APPLICATION NO.	FILING DATE	FIRST NAMED INVENTOR	ATTORNEY DOCKET NO.	CONFIRMATION NO.
09/843,002	04/25/2001	Yuji Kishida	81870.0018	7882

Office Action Summary

FIG. 2

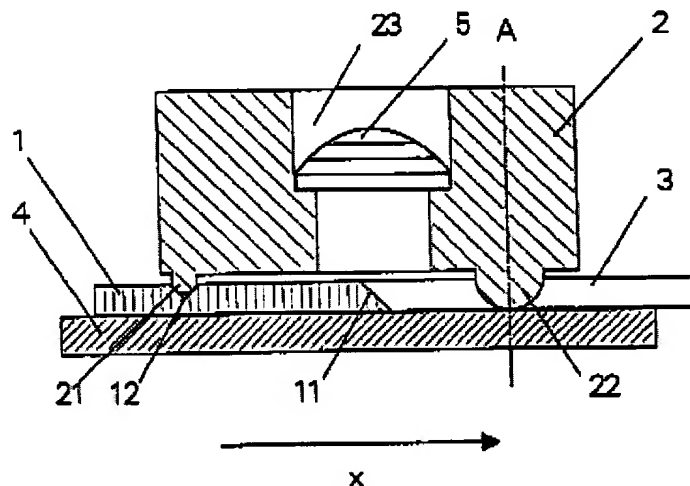
Moisel disclose an arrangement for coupling light into and coupling light out of a waveguide comprising a base plate, a mirror mount and reflecting surface positioned to the base plate and at least one waveguide and a holding device for holding optical or optoelectronic components mounted on the base plate. Not that the optical or optoelectronic components comprises one of the lenses, laser diodes, photodiodes and glass fiber connectors and the base plate comprises one of a semiconductor material, a ceramic material and a printed circuit board.

For details see figure 2 and the columns 3-4.

FIG. 7

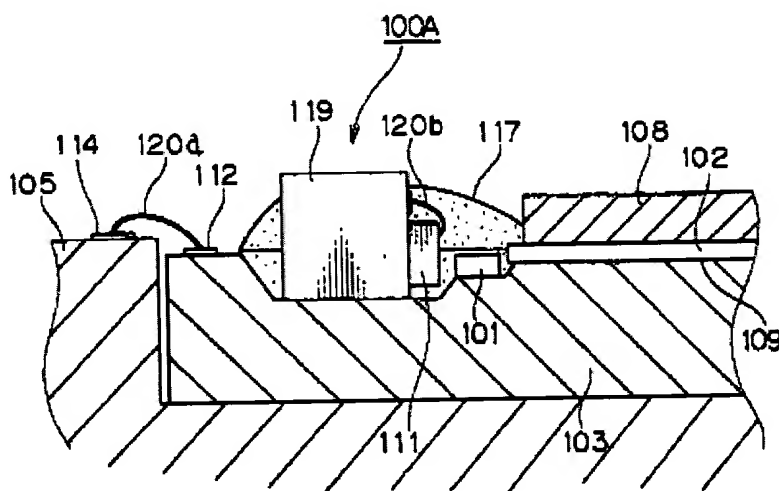
Figure 7 describes the instant invention as claimed in claim 1-3 and 5.

FIG. 3

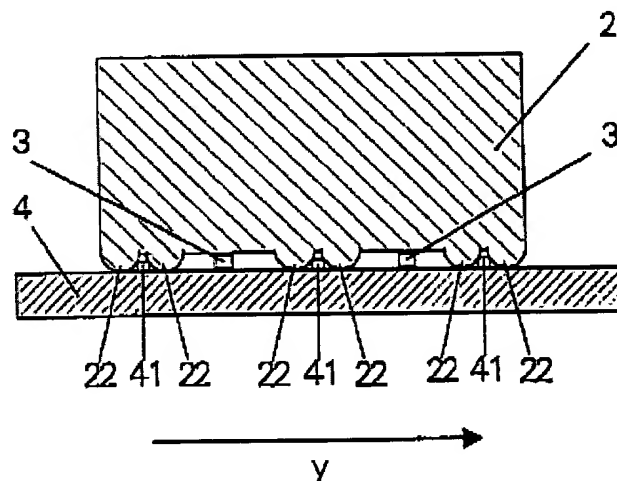
Setoguchi disclose an optical interconnection module and mounting structure thereof by which an optical fiber and an optical semiconductor device can precisely be interconnected to realize a reliable interconnection in a long term.

The module comprises a first mounting base member and a second mounting base member. At least an optical semiconductor device and an optical fiber interconnected to optical semiconductor device are held on the first mounting base member. The first mounting base member with the optical semiconductor device and the optical fiber is further fixed on the second mounting base member

Regarding claims 4 and 17, a surface of single crystalline silicon and the positioning face corresponds to surface equivalent to surface of the single crystalline silicon, which is mentioned in column 11 of the reference (third paragraph).
